Commonwealth Edison Company

August 31, 1971

Subject: Proposed Change No. 14 to Appendix A,
DPR-19, AEC Dkt 50-237

TRANSIENT ANALYSES OF PROPOSED TESTS FOR WHICH A TEMPORARY WAIVER OF FLOW
REFERENCED SCRAM IS REQUESTED AND A FIXED 120% APRM FLUX SCRAM IS PROVIDED

Fig 3A-2

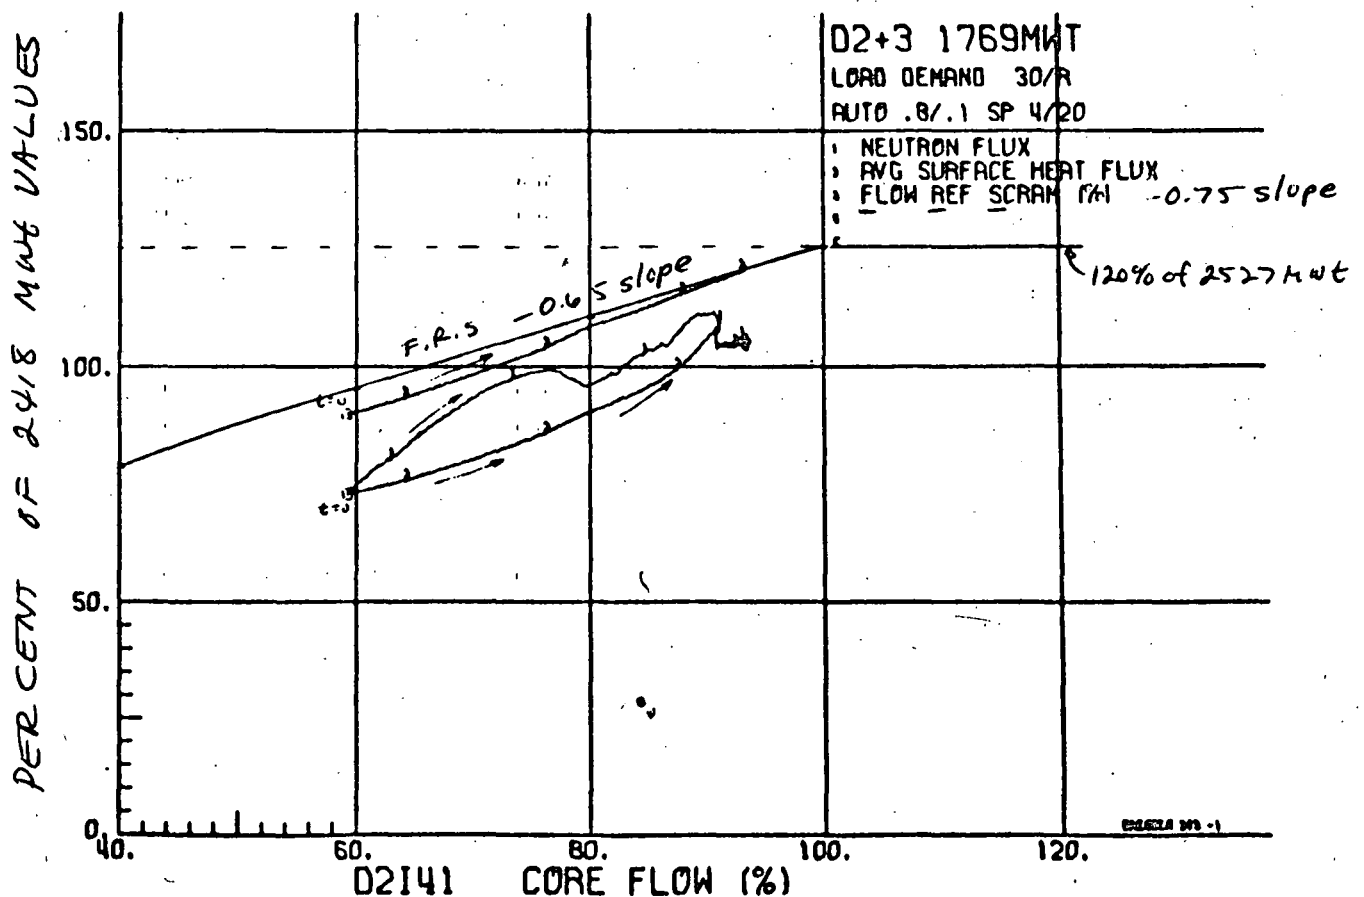
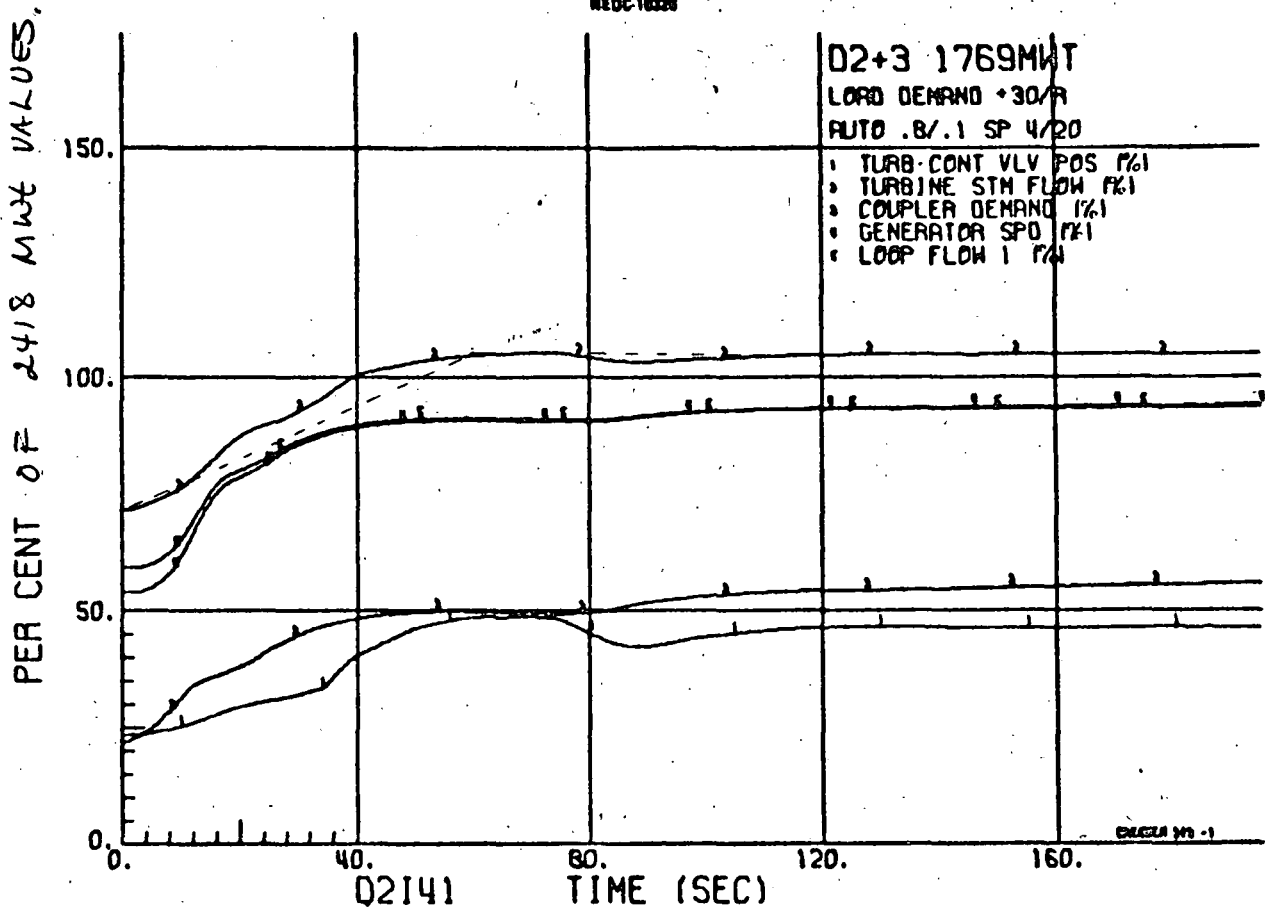
Figures 3A-1 and 3A-2 show the plant response to a 30% ramp increase in load demand at a demand rate of $2 \frac{1}{2}\%$ per second. The ^{dashed} dsched line on the top plots of Figure 3A-2 shows the minimum desired response to a 30% ramp demand of 0.5% per second. Again, note the proximity of the flow referenced scram line. *

The $\pm 3\%$ per minute load changes are at a rate much less than the capability of the flow control system. As seen on Figures 3A-1 and 3A-2 the response rate can be as large as 0.5% per second or 30% per minute. All tests performed to demonstrate the $\pm 3\%$ per minute capability over the load range from 15% to 100% will have responses that fall well within the analysis of the 30% per minute response shown on Figures 3A-1 and 3A-2. Only those tests that approach the 30% per minute response rate are expected to show interference by flow referenced scram.
